Re: Item PG18.5 – Proposed Technical Amendments to By-law 569-2013
RA King Portland Nominee Inc: 602-622 King Street West

RE: Amendments to By-law 569-2013 (Section 200.15)

Proposed Adjustments to Accessible Parking Spaces
Submitted to the Planning & Growth Management Committee

Figure 1

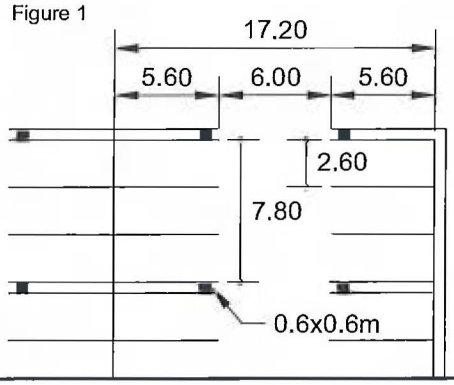
The impact to development of the proposed change is significant. The current width of 3 City of Toronto parking spaces (the typical number of spaces that fit within a typical structural grid in an above- or below-grade parking structure) is 7.8m plus the width of adjacent columns (Figure 1). Three typical spaces can be replaced with 2 AODA-compliant accessible parking spaces (3.4m "Type A" + 1.5m aisle + 2.4m "Type B" = 7.3m, Figure 2). Replacing 3 typical spaces with 2 proposal-compliant accessible spaces results in a required width of 8.3m (Figure 3). This exceeds the typical structural grid used in above- or below-grade parking facilities and may require structural changes near accessible spaces.

Our recommendation would be to adopt the sharing rules (between Type A and Type B spaces) as set out in the AODA and to adjust the length requirement to 5.6m so as to be compliant with the AODA and to be compatible with other critical zoning by-law parking dimensions.

Figure 4

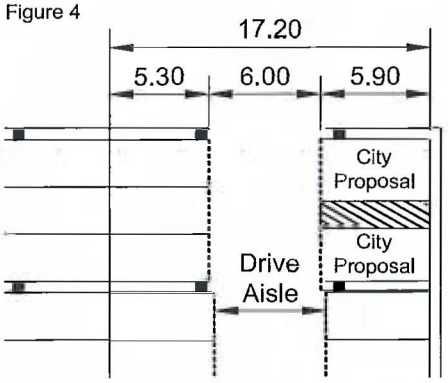
1) Drivers, travelling down the drive aisle, would see the 6.0m aisle "jog" to the side as they travelled, resulting in a less safe condition within the parking area (Figure 4).
2) Parking spaces opposite the barrier free spaces may become shorter (5.3m in length) which would require by-law relief (Figure 4). Without relief all parking spaces within the impacted zone would be forced to shift (with parking spaces also shifting the entirety of the parking area) or resulting in the creation of unusable space within the parking area (Figure 5).
3) If structural grids could not be adjusted to accommodate the shifts required by the longer spaces, some parking spaces might violate the City's "obstruction rule" within the By-law (200.5.1.10 (D)), resulting in the need to seek relief from the rule through a variance or Site Specific By-law (Figure 6).
